<b>AMENDMENT OF SOLICITATION/MODIFICATION OF CONTRACT</b>				1. CONTRACT ID CODE	PAGE 1 OF 3 PAGES
2. AMENDMENT/MODIFICATION NO. AMENDMENT NO. 0001		3. EFFECTIVE DATE 08/24/09	4. REQUISITION/PURCHASE REQ. NO.	5. PROJECT NO. (If applicable) 09-0270	
6. ISSUED BY CODE KJ  Officer in Charge of Construction MCI-East 1005 Michael Road Camp Lejeune, NC 28547-2521		7. ADMINISTERED BY (If other than Item 6) CODE  See Item 6			
8. NAME AND ADDRESS OF CONTRACTOR (No., street, county, State and ZIP Code)				(X)	9A. AMENDMENT OF SOLICITATION NO.  N40085-09-R-0270
				X	9B. DATED (SEE ITEM 11) 08/14/09
CODE _____ FACILITY CODE _____					10A. MODIFICATION OF CONTRACT/ORDER NO.
					10B. DATED (SEE ITEM 11)

09-0270, Install Additional Parking At Building AS100

CONTINUATION SHEET

C1.2

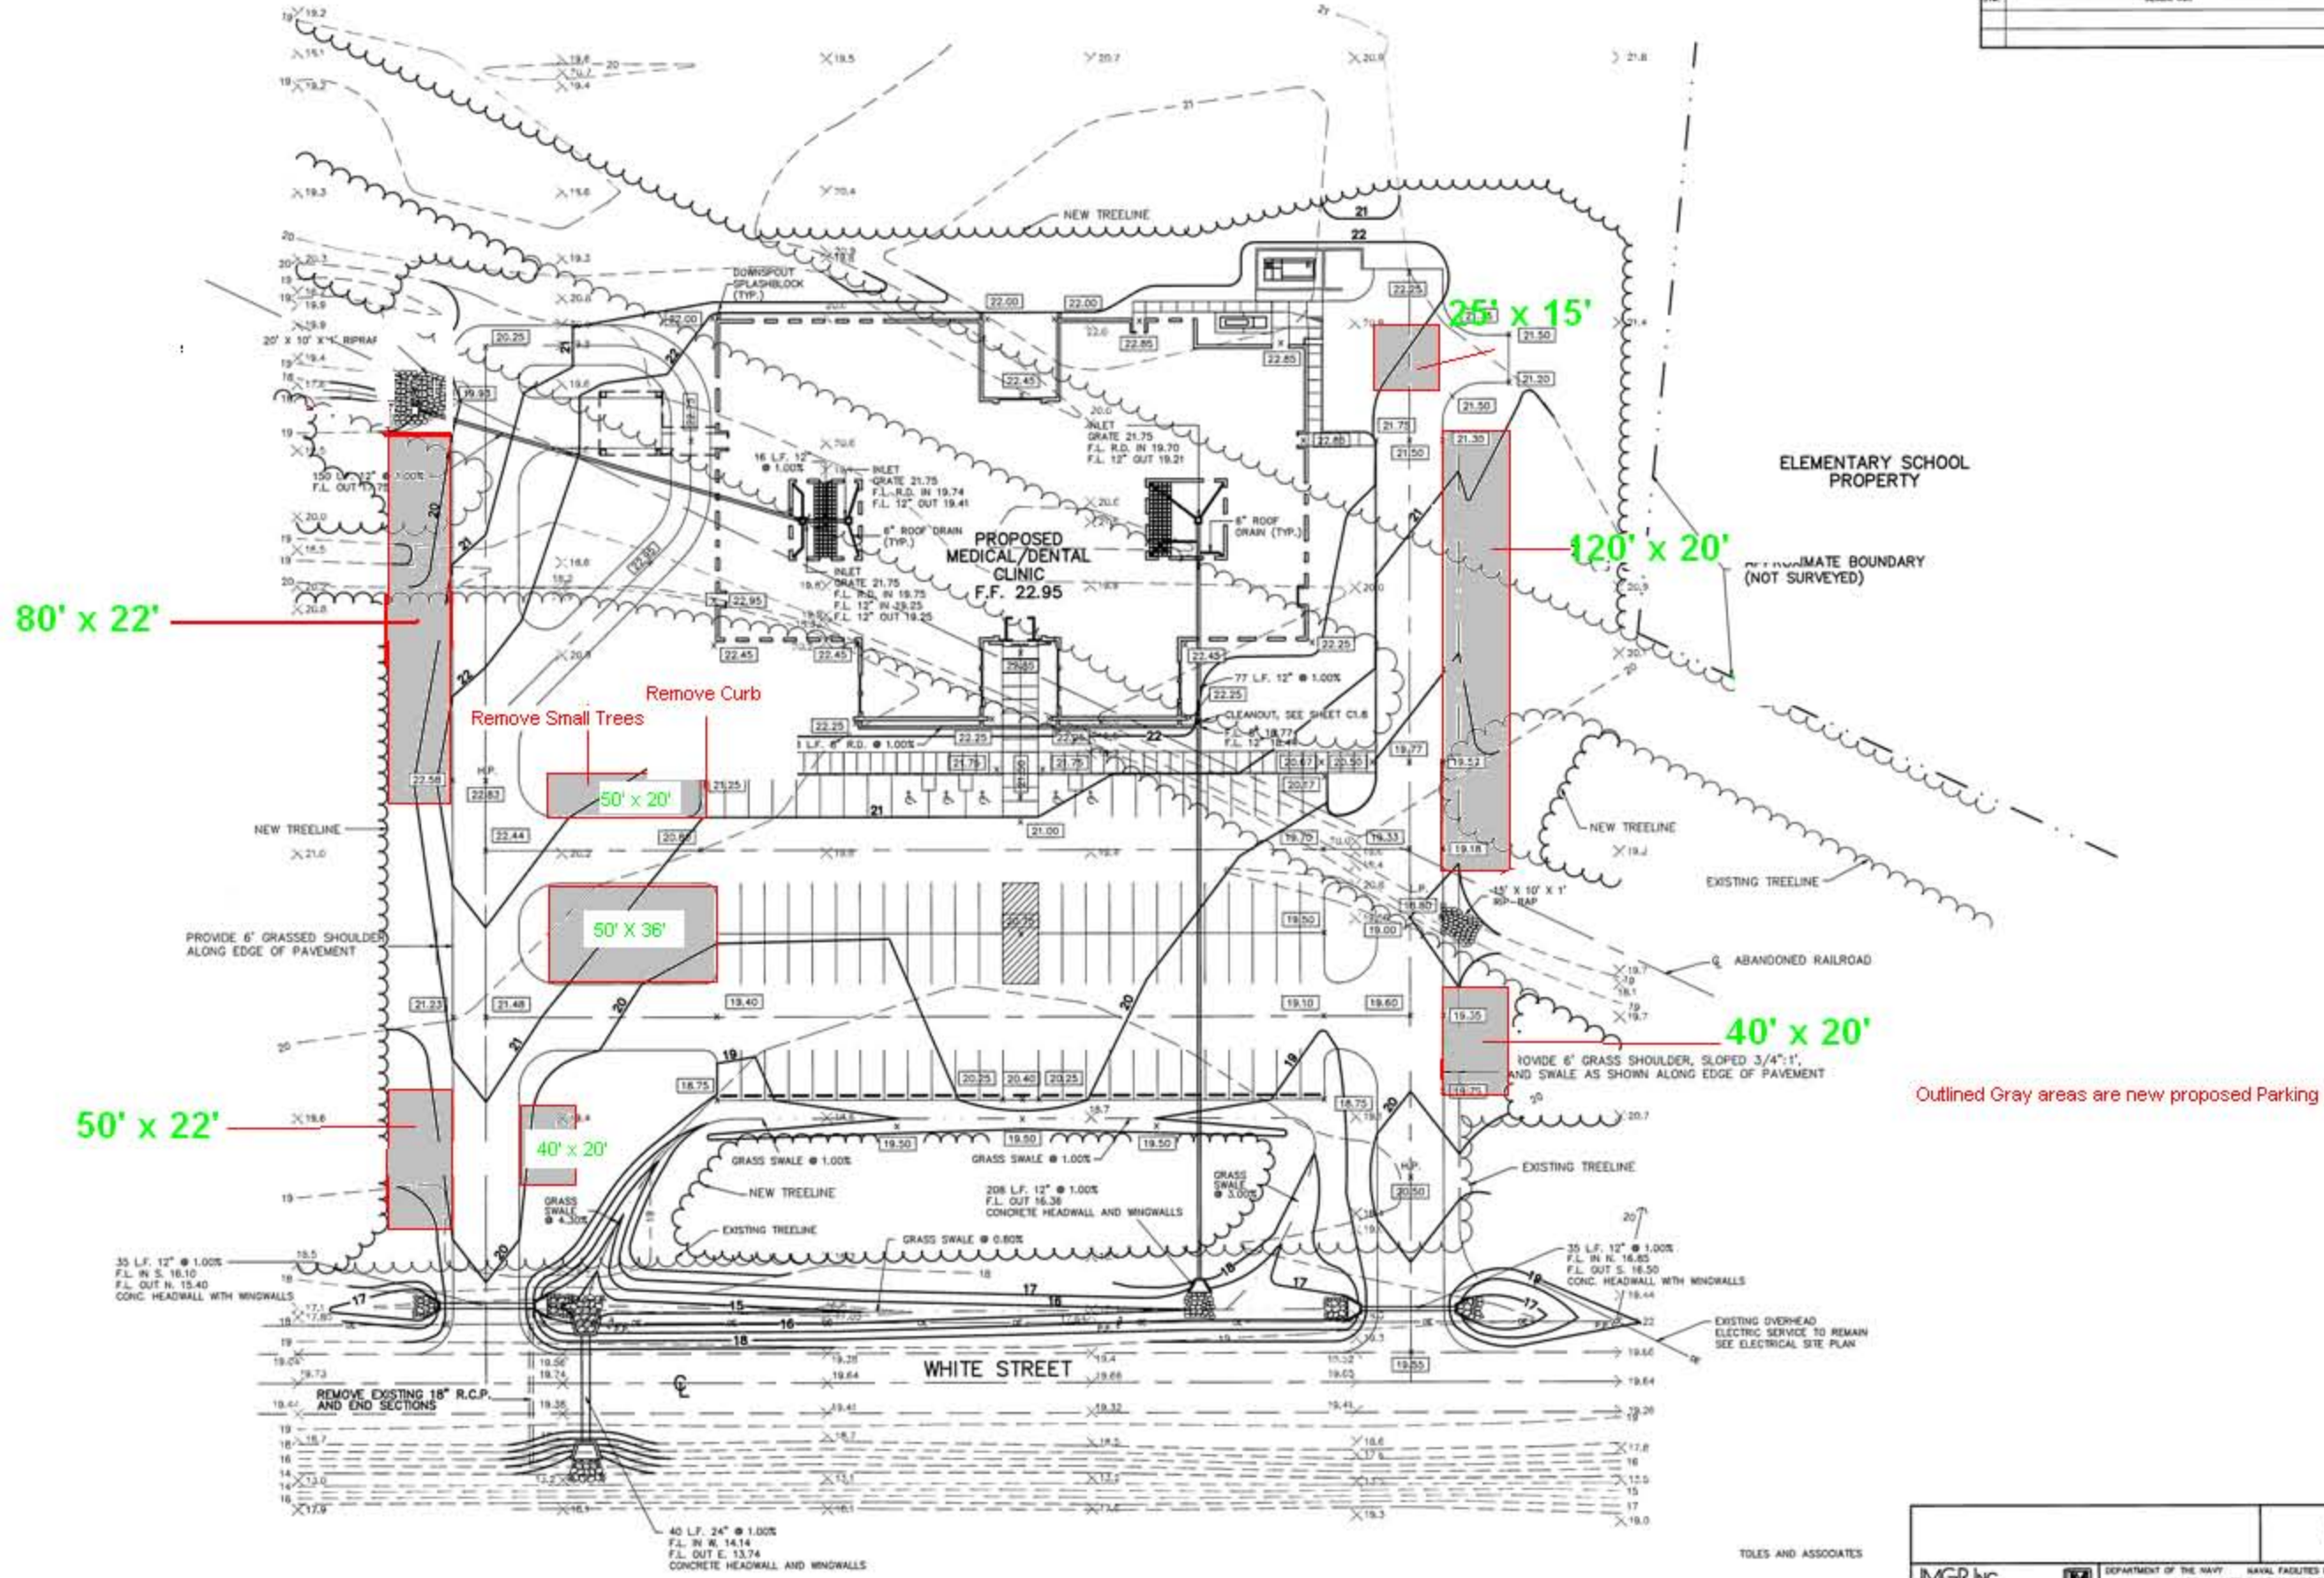
- 4.) Incorporate the drawing shown on page three of this amendment into the solicitation/contract, which identify the areas.

Outlined Gray areas are new proposed Parking
